5TH & LENORA

DRB#1 - SUMMARY

New Street Trees
- DRB#1 SITE PLAN
- 
- DRB#2 REVISED SITE PLAN
- 
- 16
- 5TH & LENORA | PROJECT #3026266  
RECOMMENDATION MEETING #2 07.10.2018
-

FLASHING DETAILS

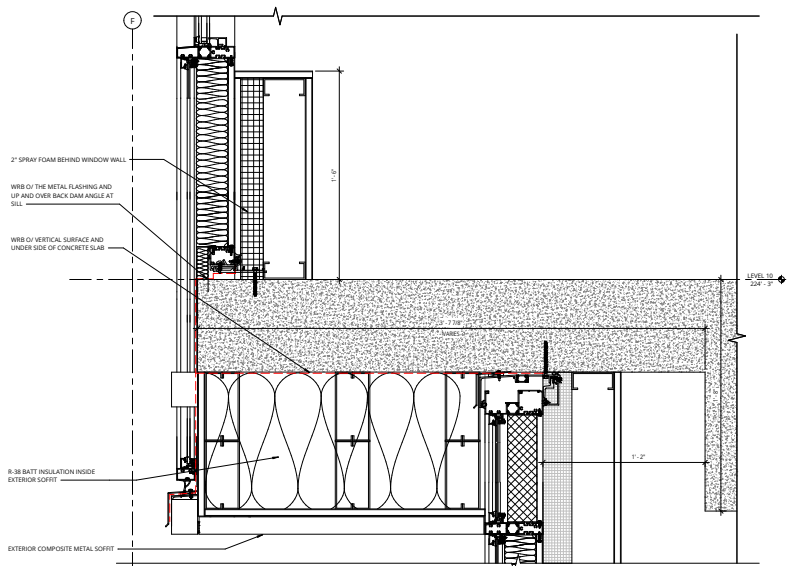
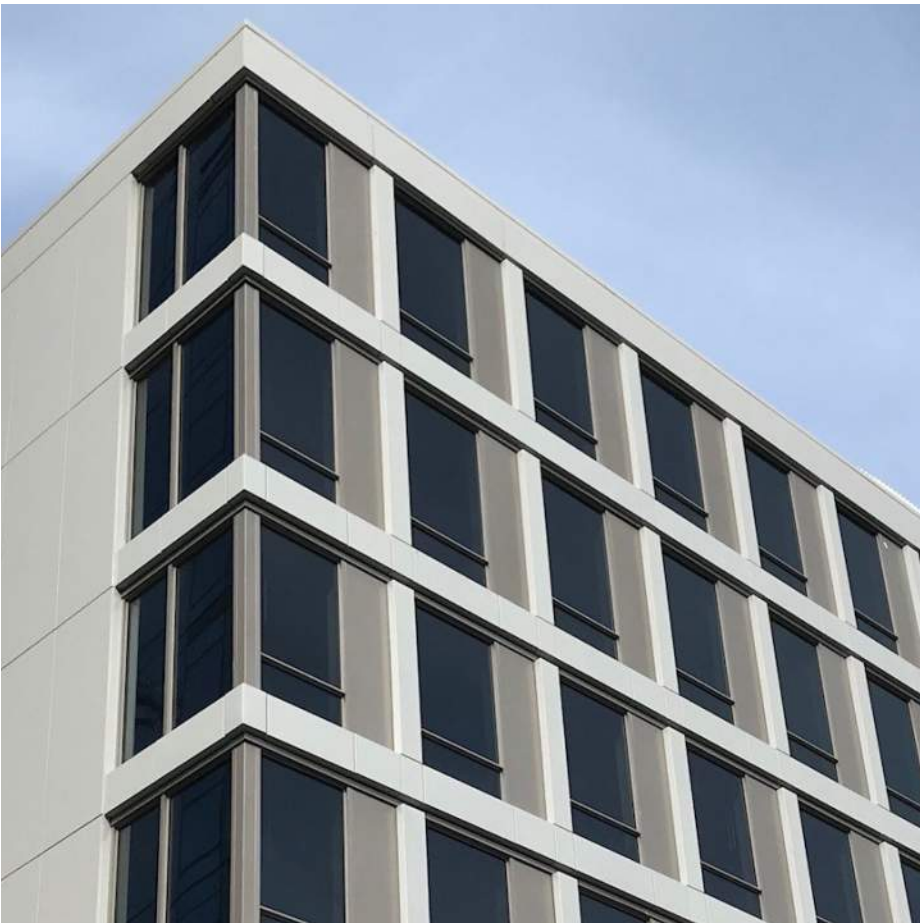
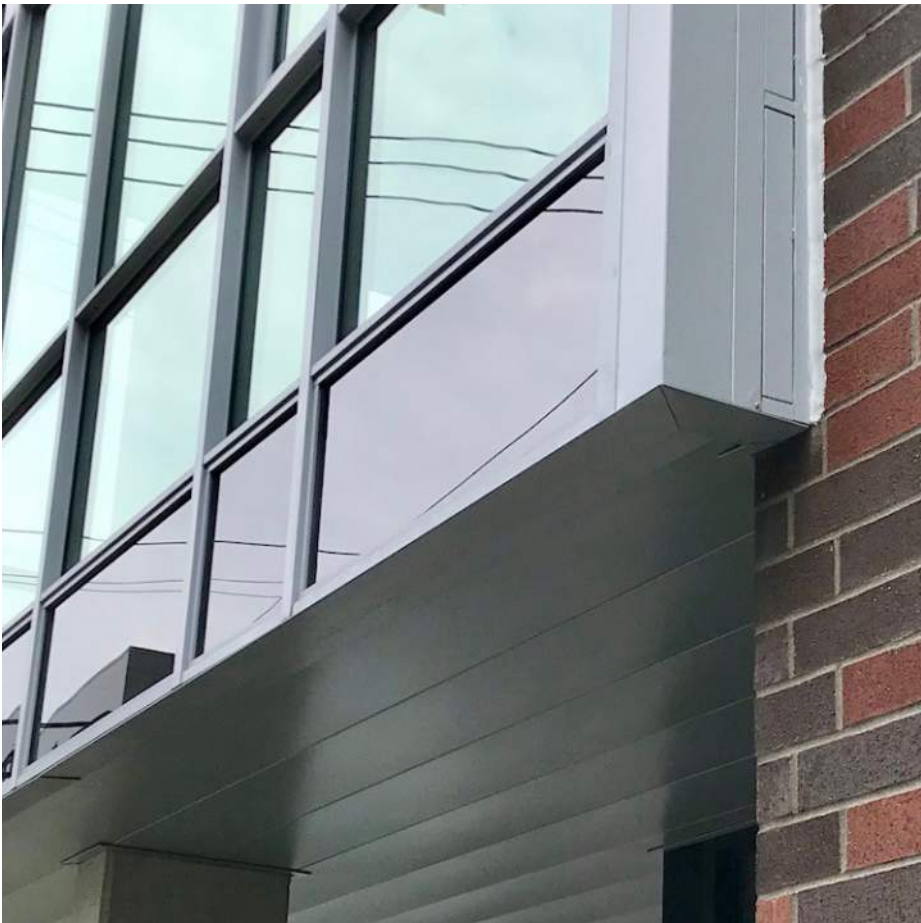
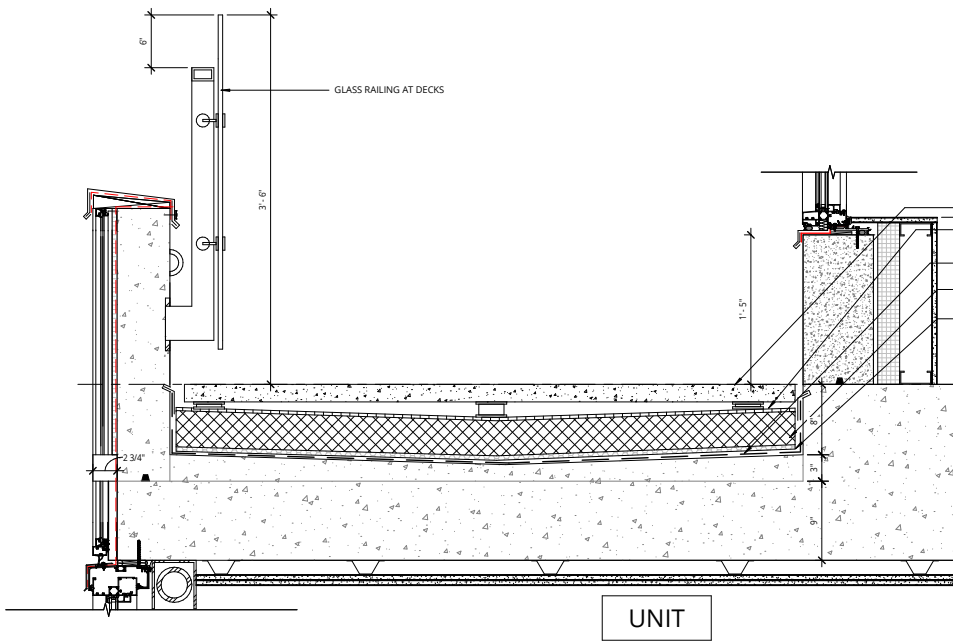
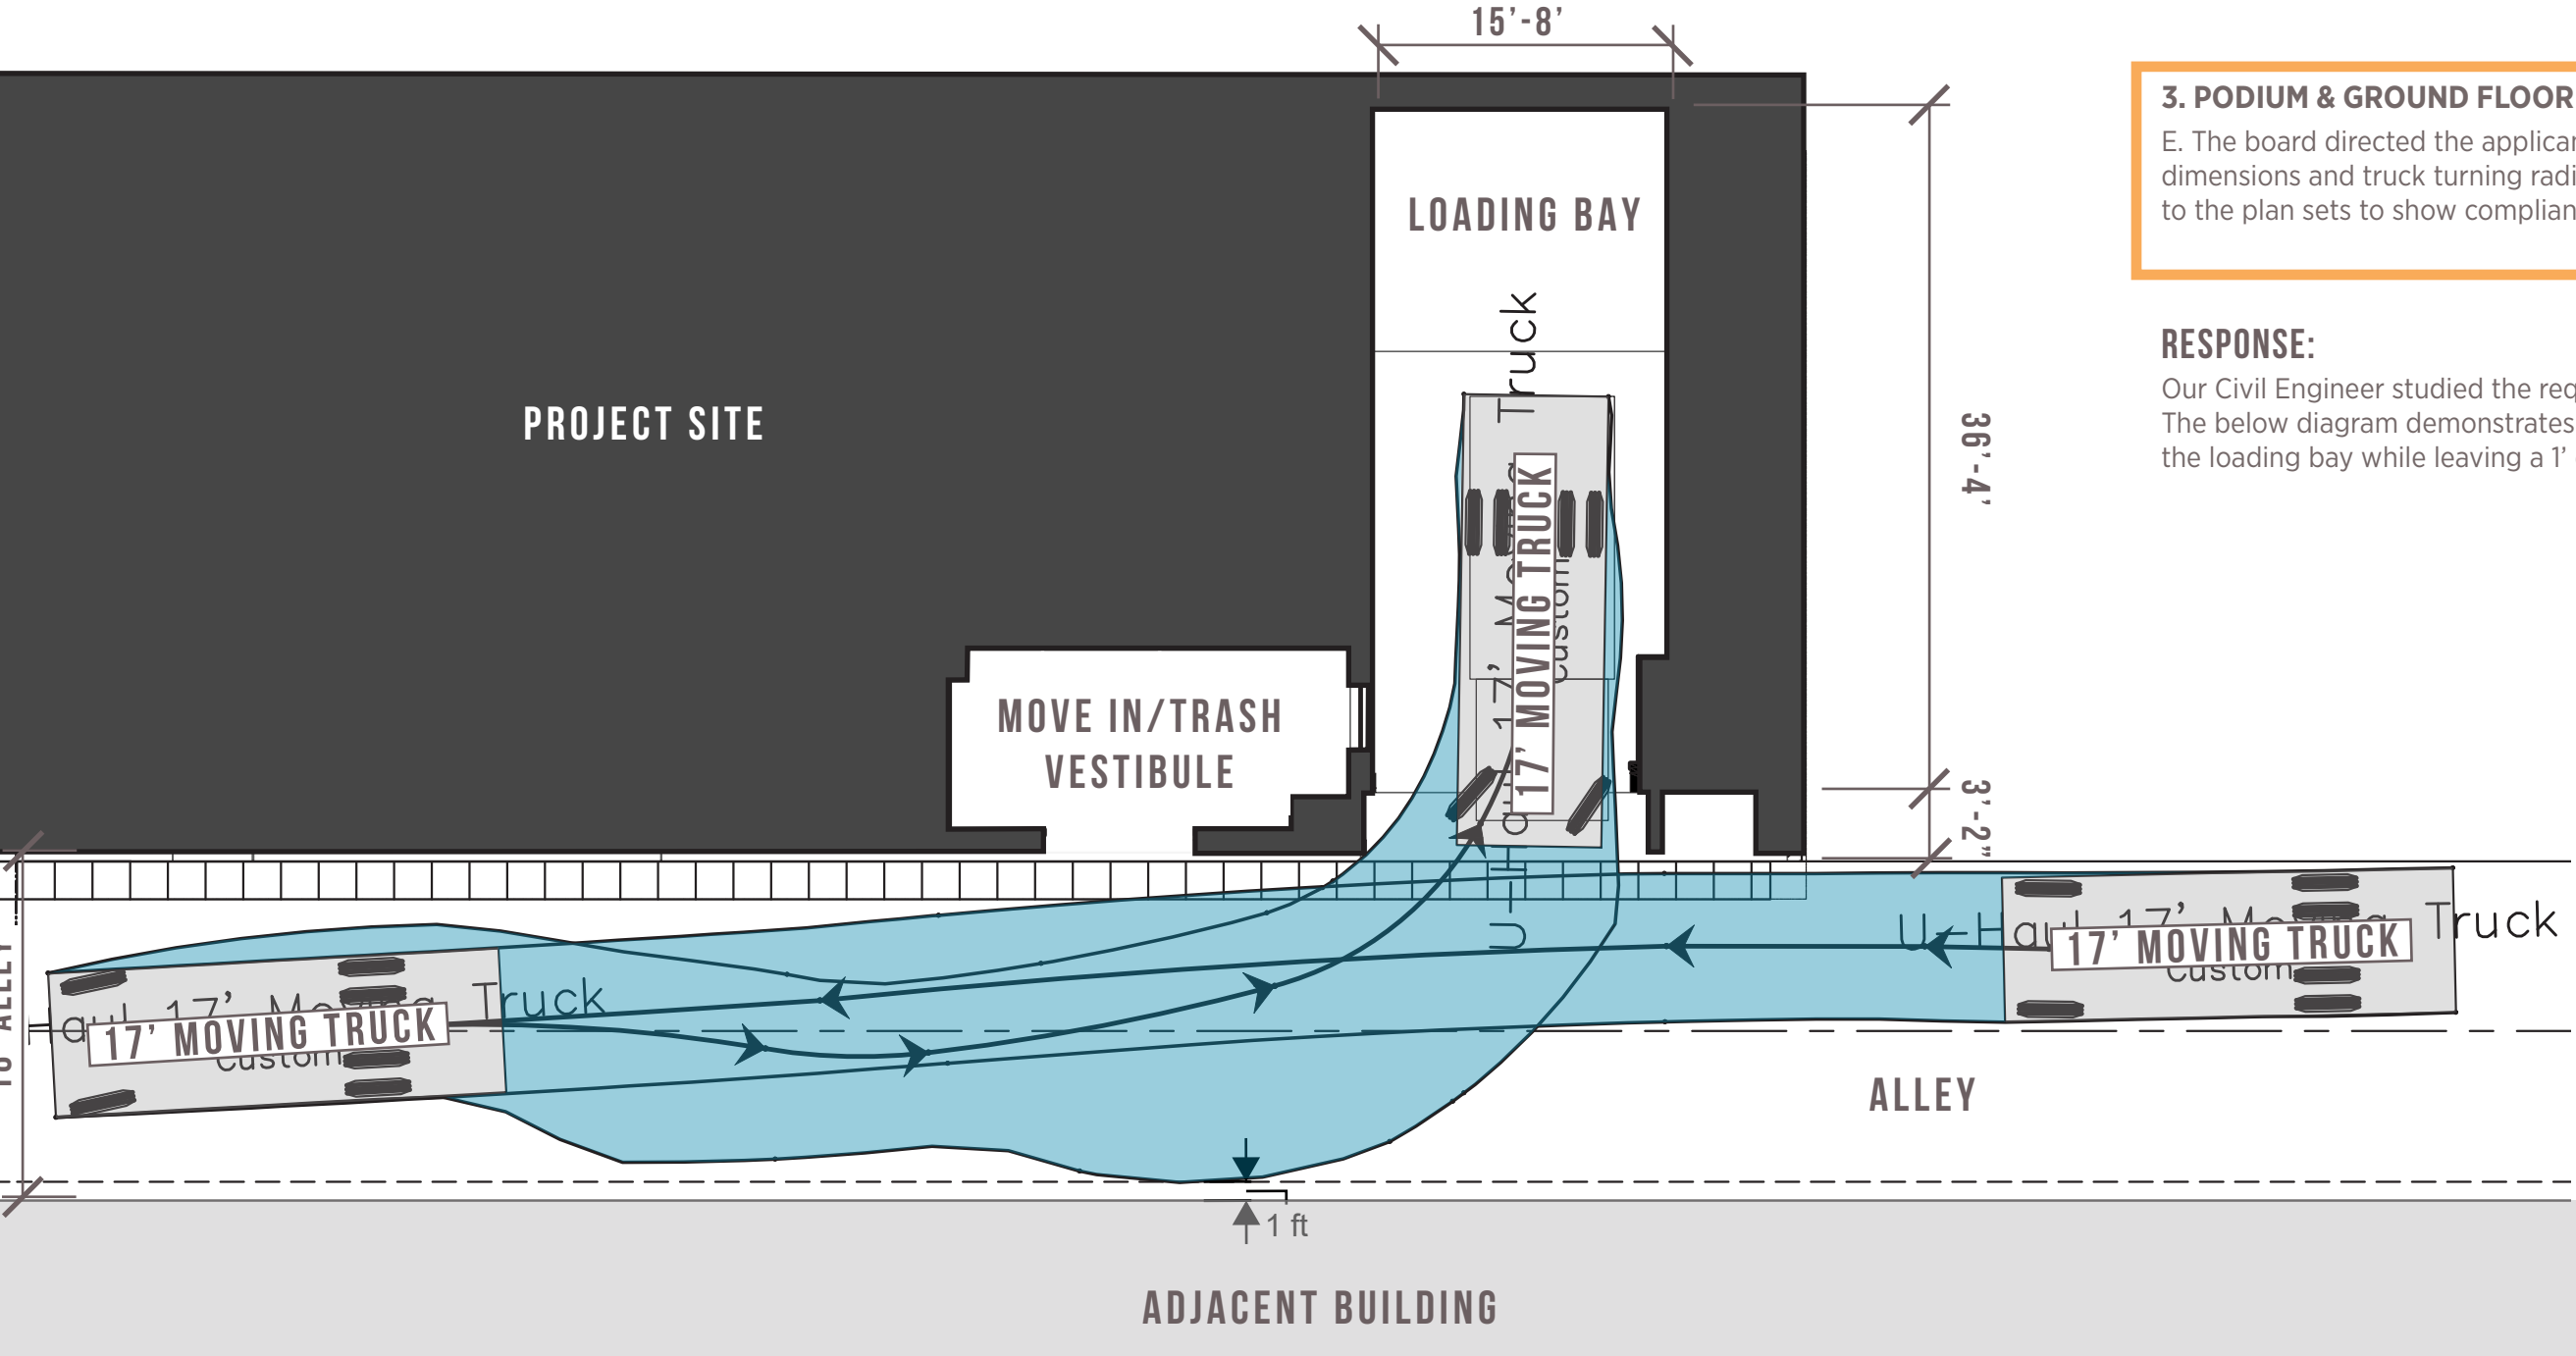
D. The board directed the applicant to add a joint pattern in the painted concrete alley wall that corresponds to the joint patterning in levels above for increased melding of the façade elements. The Board also recommended that a detail be provided to assure that no flashing is used at the edges of the trays so there is a crisp, clean edge that appears as an extension of the glazed tray elements. (B4.3)

**RESPONSE:**  
Please refer to design details provided in our response to guidance item #2.b for proposed coping details at the tray step parapets.

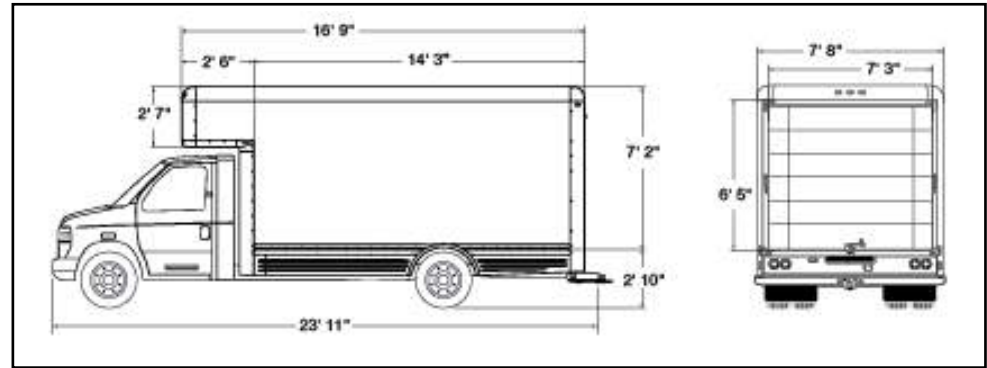
E. The board directed the applicant to add loading area dimensions and truck turning radius/sweep diagrams to the plan sets to show compliance. (C6.1)

Our Civil Engineer studied the requirements of a 17' move in truck. The below diagram demonstrates the ability of the truck to enter the loading bay while leaving a 1' clearance of the adjacent building.
